THIS PLAN TO BE READ IN CONJUNCTION WITH
MOD2016/0298
NORTHERN BEACHES COUNCIL

Harbord Diggers
80 Evans Street Freshwater

SECTION 96

drawing
Elevation 1 Evans Street

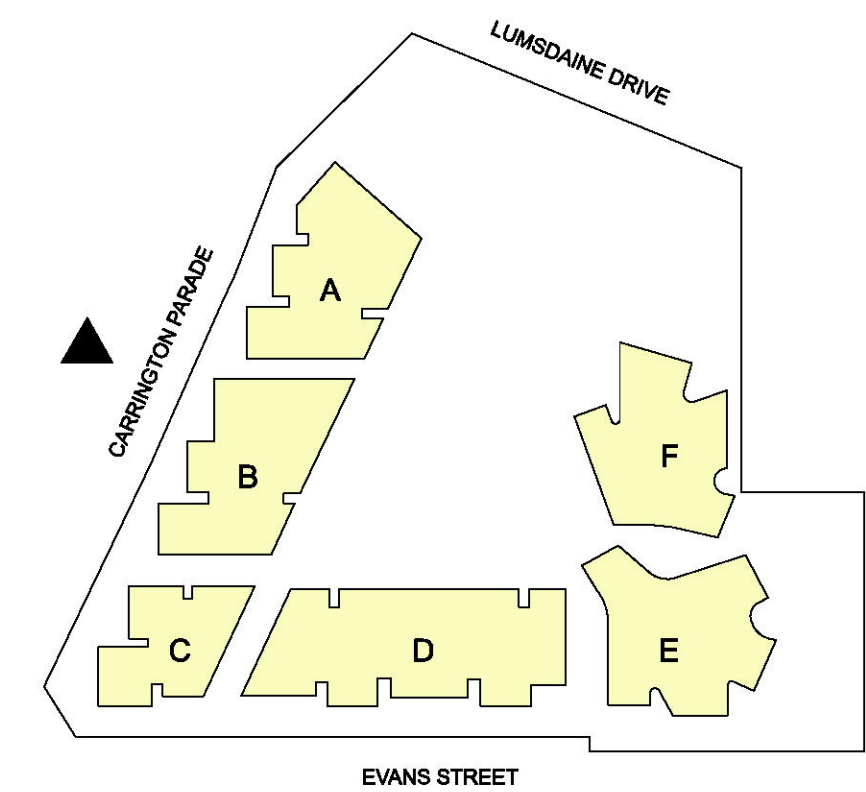
GENERAL NOTES:
- Minor adjustments to window sizing and placement
- Minor reduction in sliding screen quantities

Minor adjustment to material palette

drawing
Elevation 2 Carrington Parade

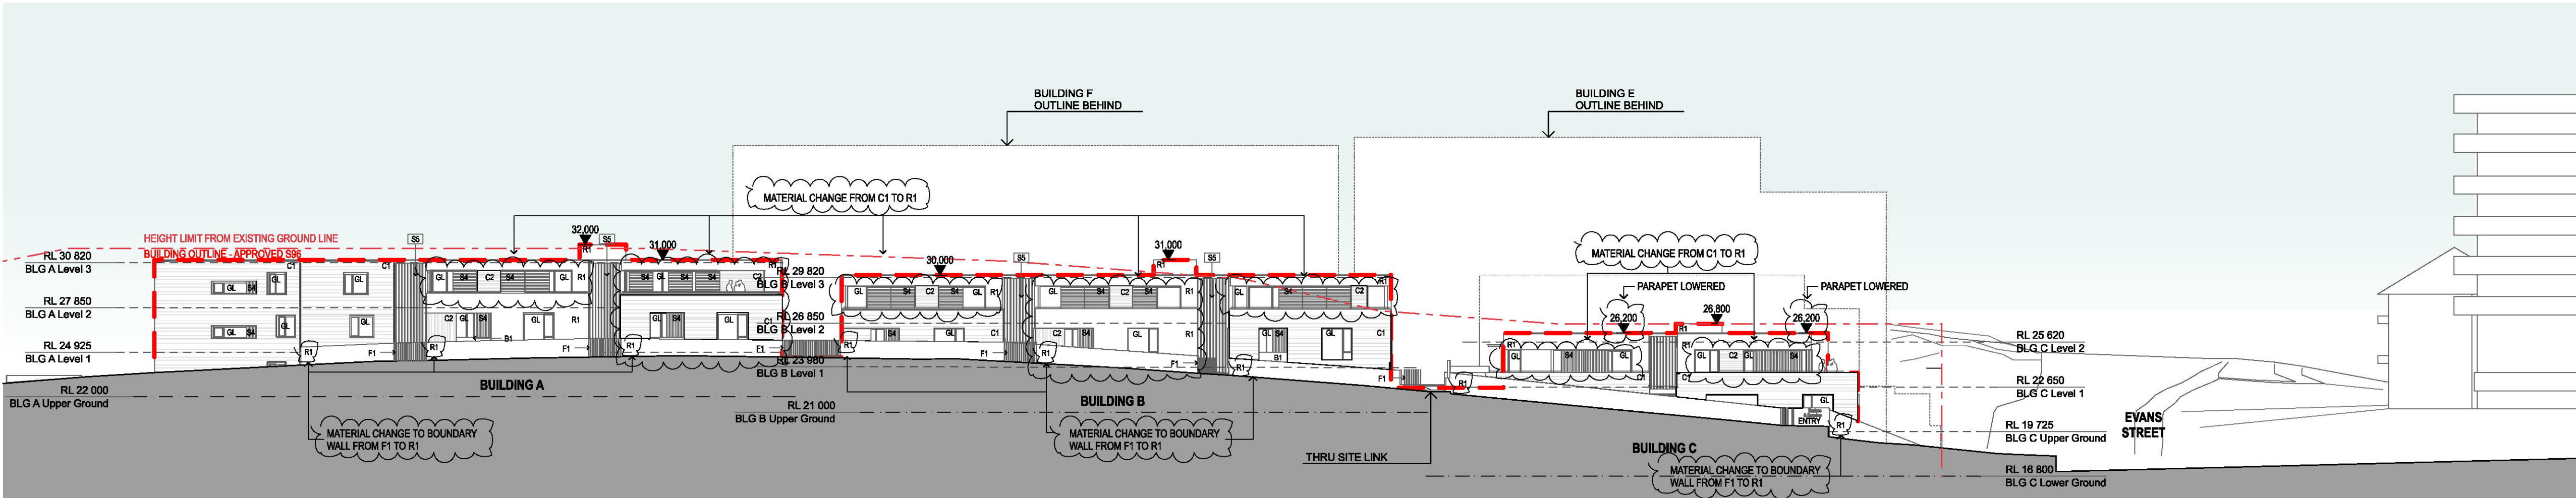
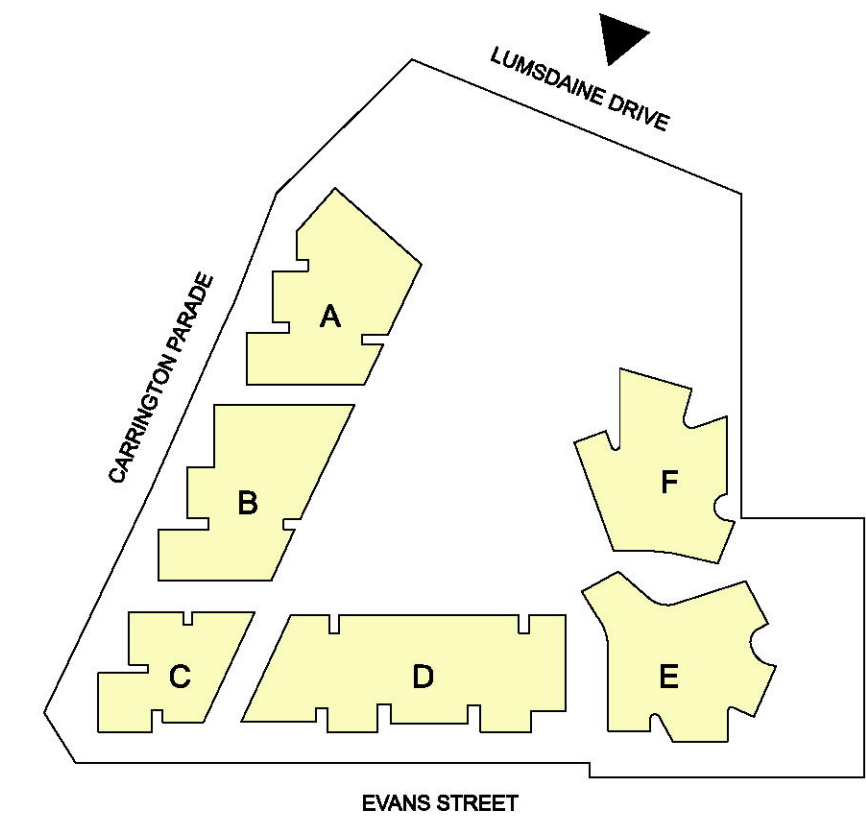
GENERAL NOTES:
- Minor adjustments to window sizing and placement
- Minor reduction in sliding screen quantities

Minor adjustment to material palette

drawing
Elevation 3 Lumsdaine Drive

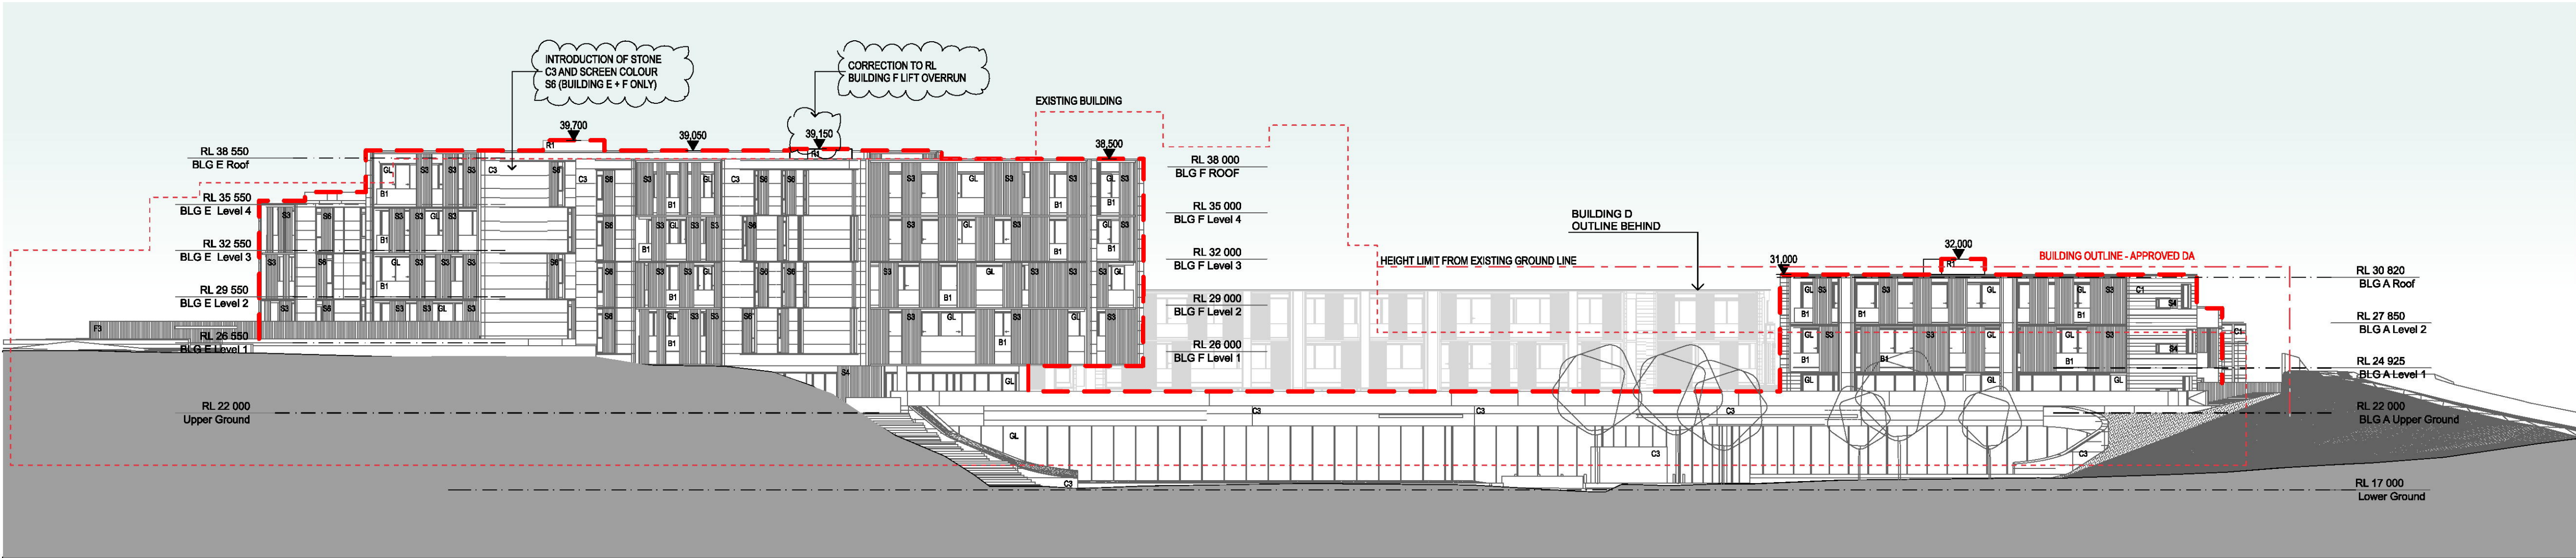
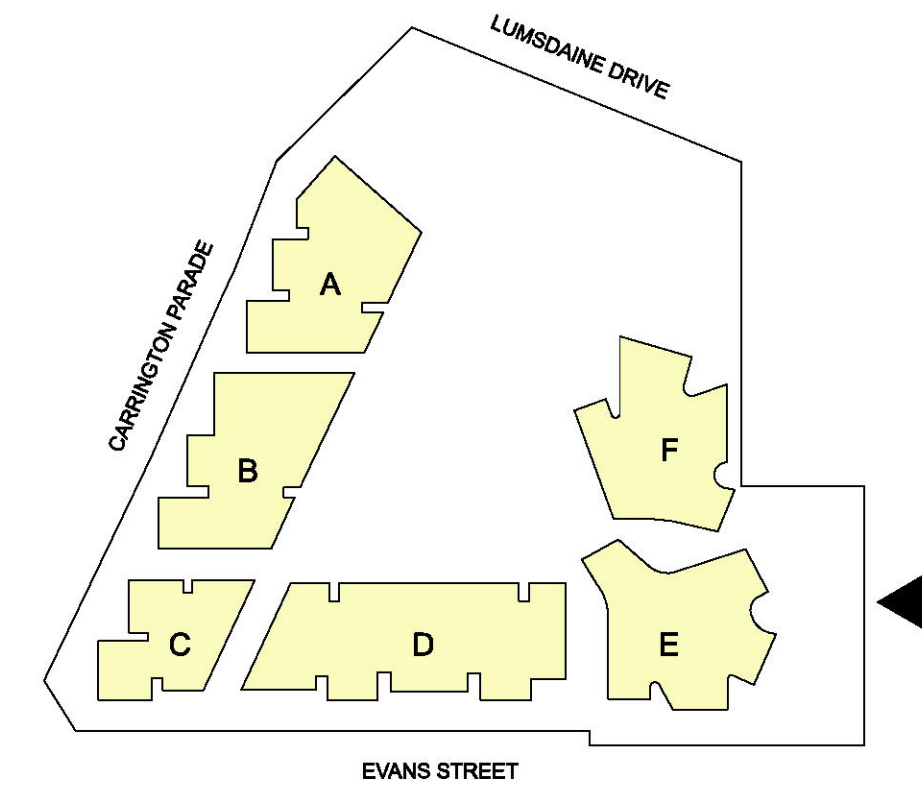
GENERAL NOTES:
- Minor adjustments to window sizing and placement
- Minor reduction in sliding screen quantities

Minor adjustment to material palette

drawing
Elevation 4 McKillop Park

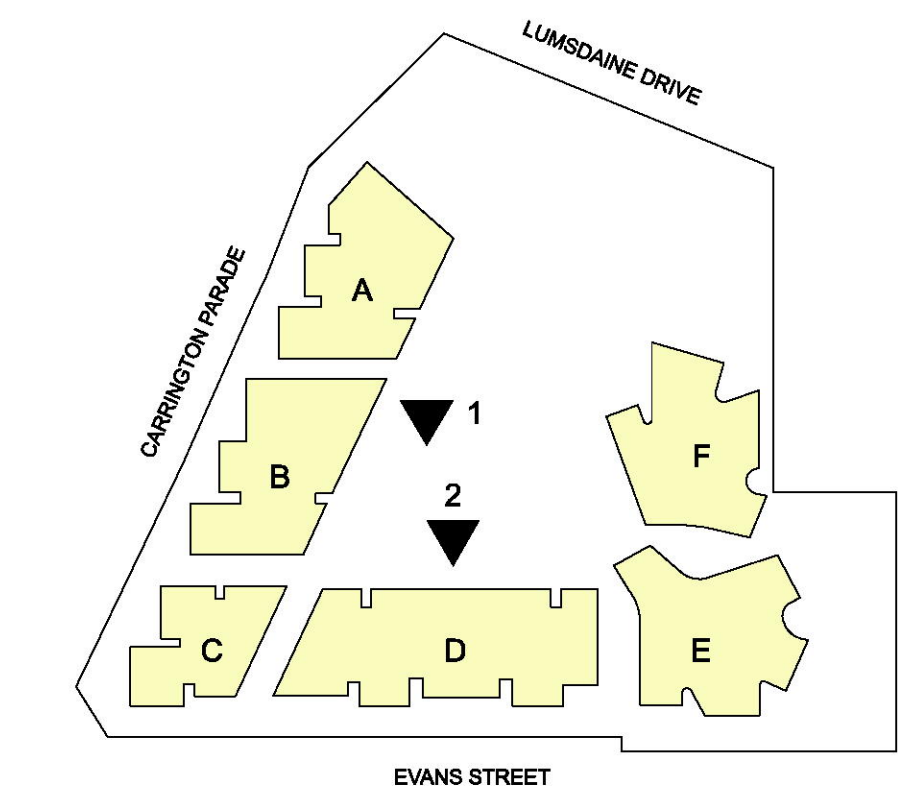
GENERAL NOTES:
- Minor adjustments to window sizing and placement
- Minor reduction in sliding screen quantities

Minor adjustment to material palette

drawing Courtyard Elevations - Sheet 1

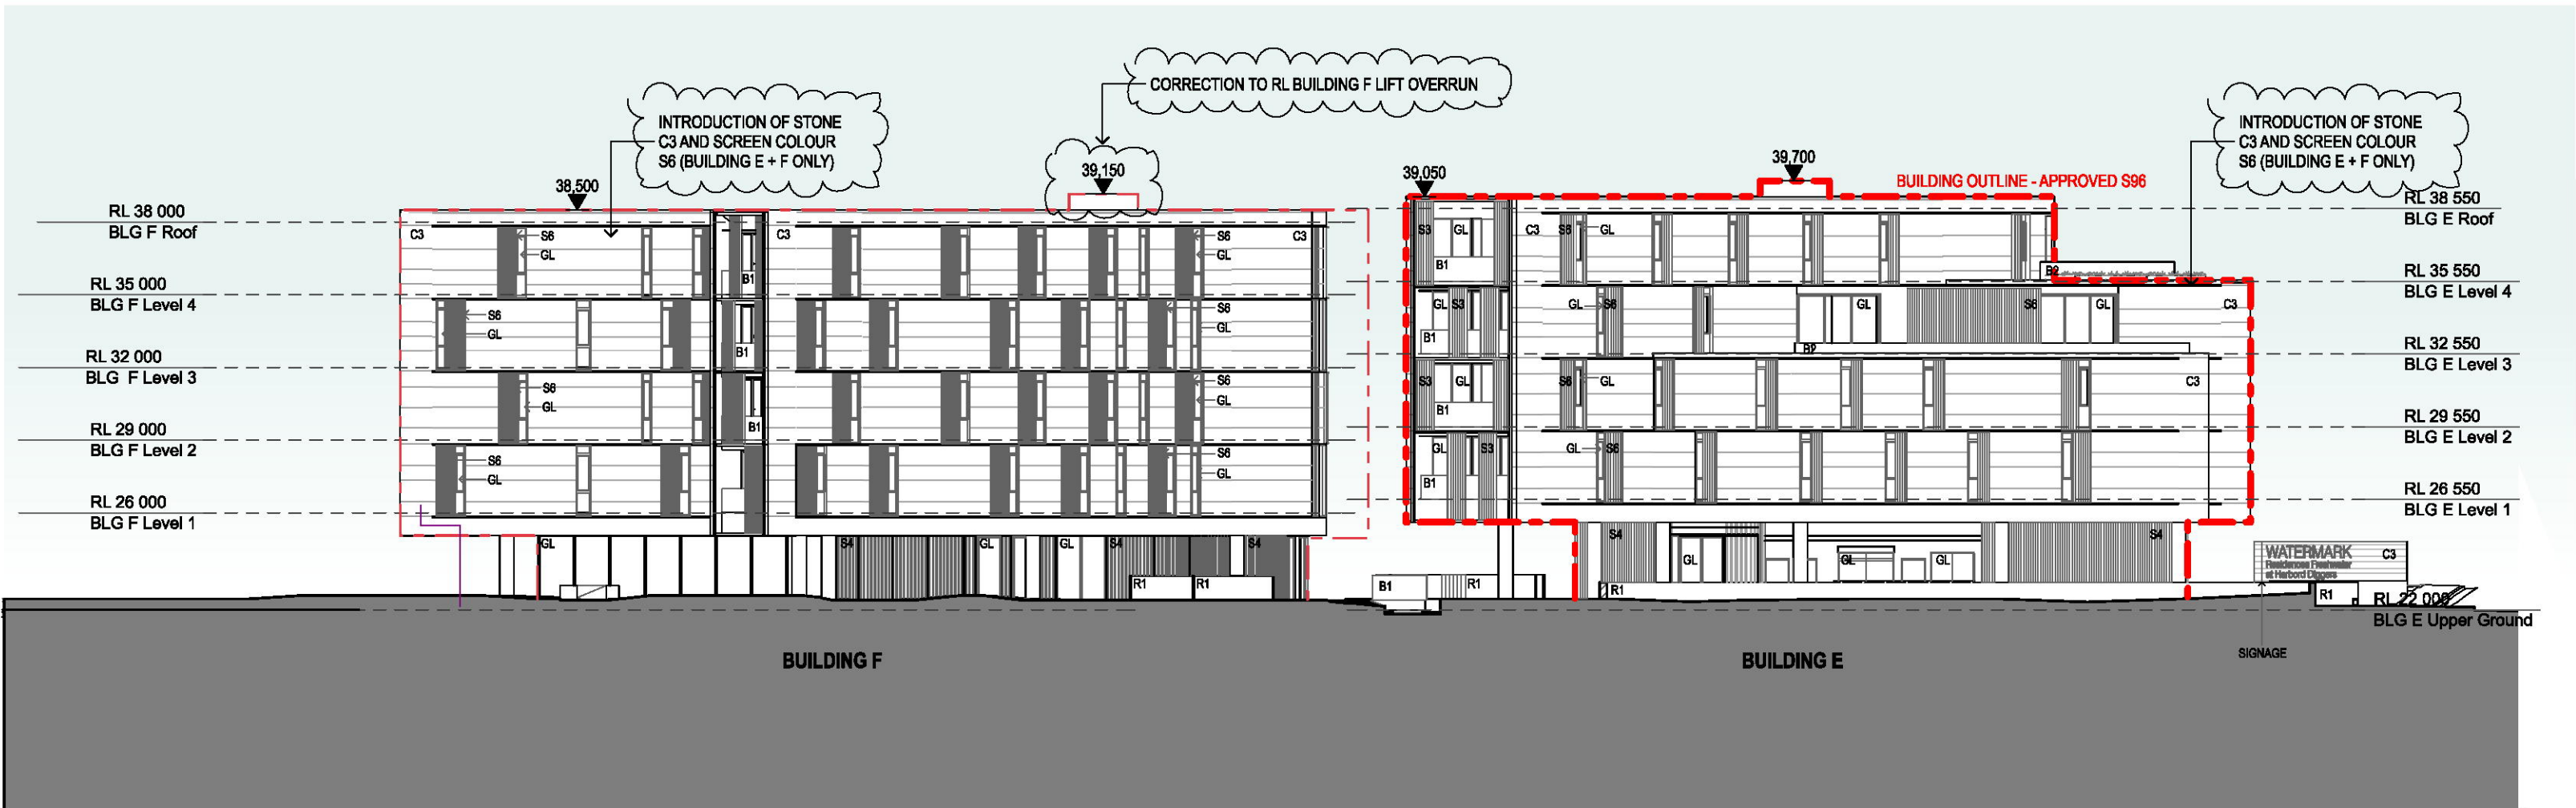
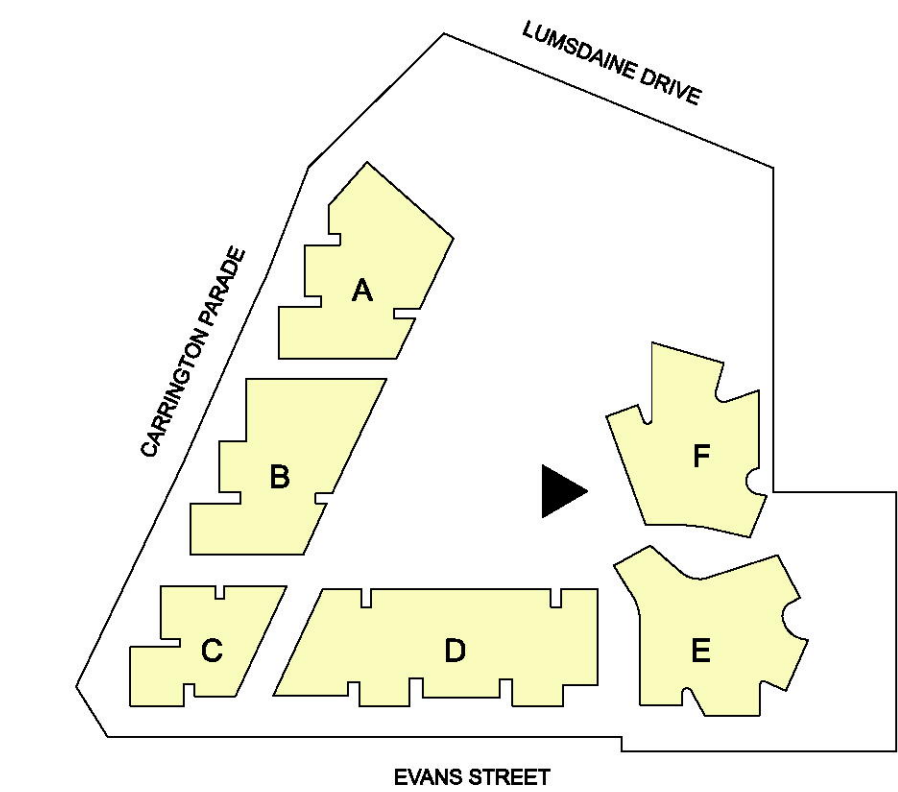
GENERAL NOTES:
- Minor adjustments to window sizing and placement
- Minor reduction in sliding screen quantities

Minor adjustment to material palette

drawing
Courtyard Elevations - Sheet 2

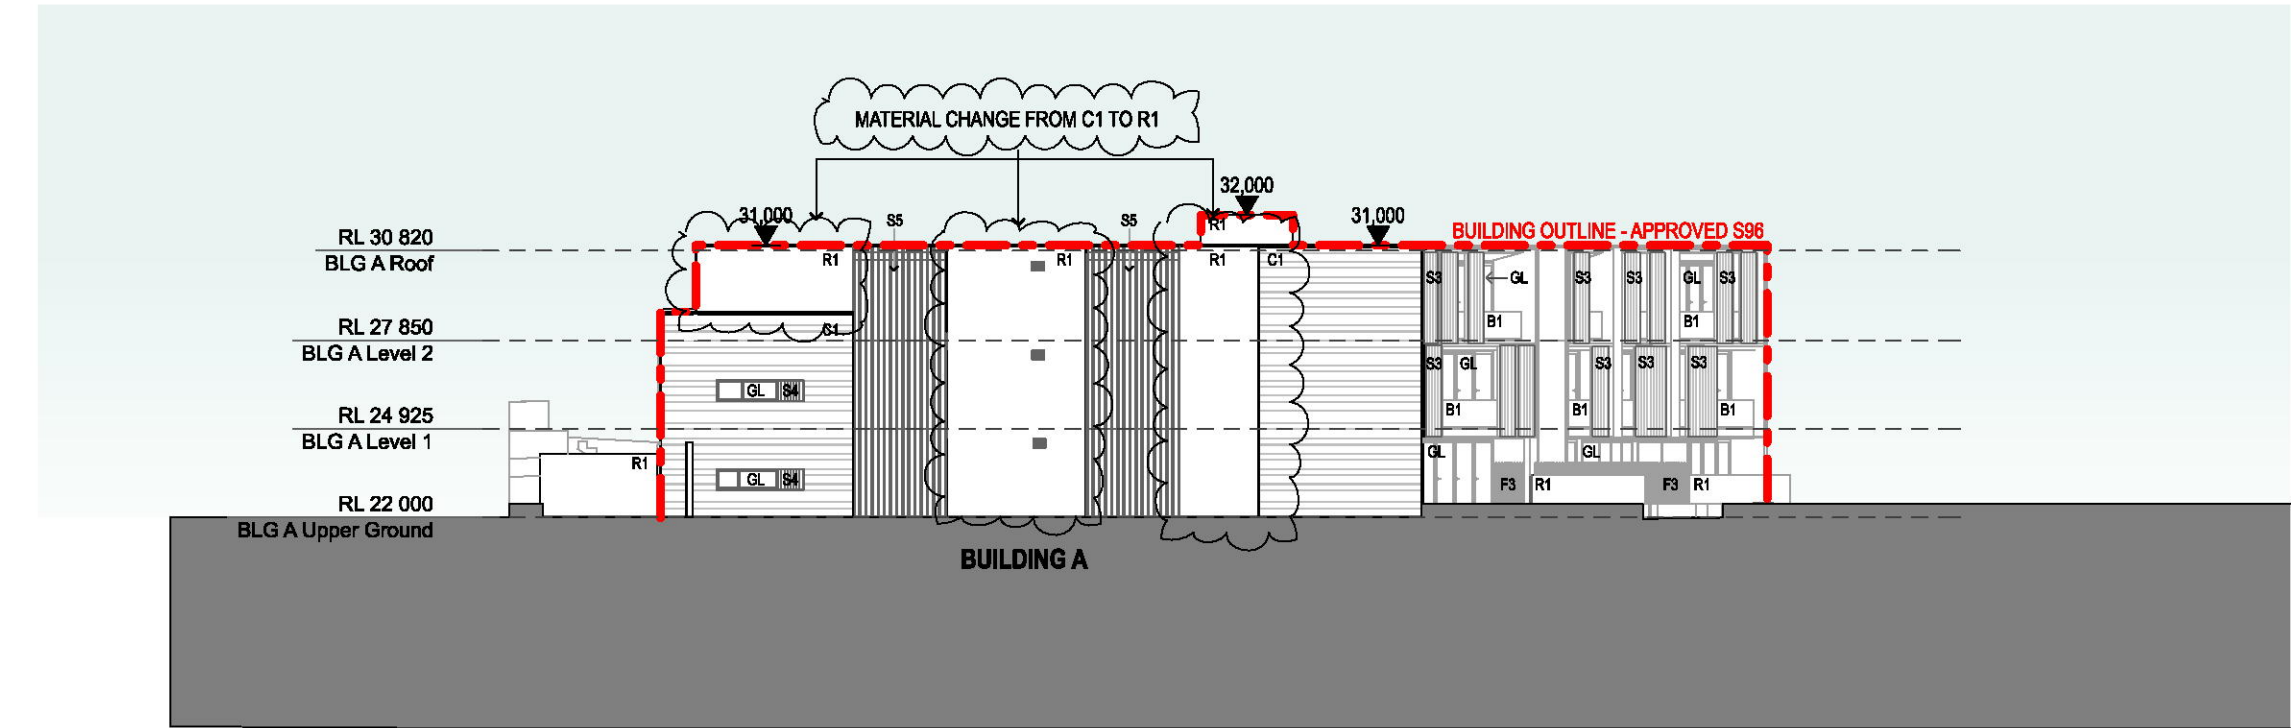
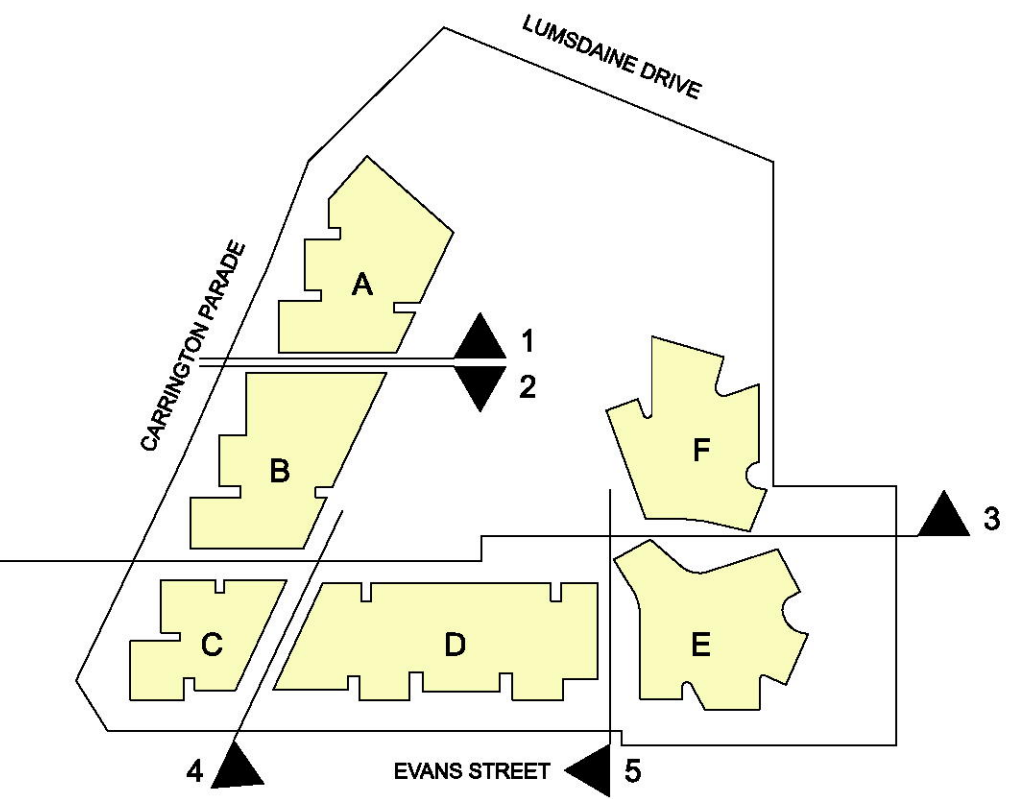
GENERAL NOTES:
- Minor adjustments to window sizing and placement
- Minor reduction in sliding screen quantities

Minor adjustment to material palette
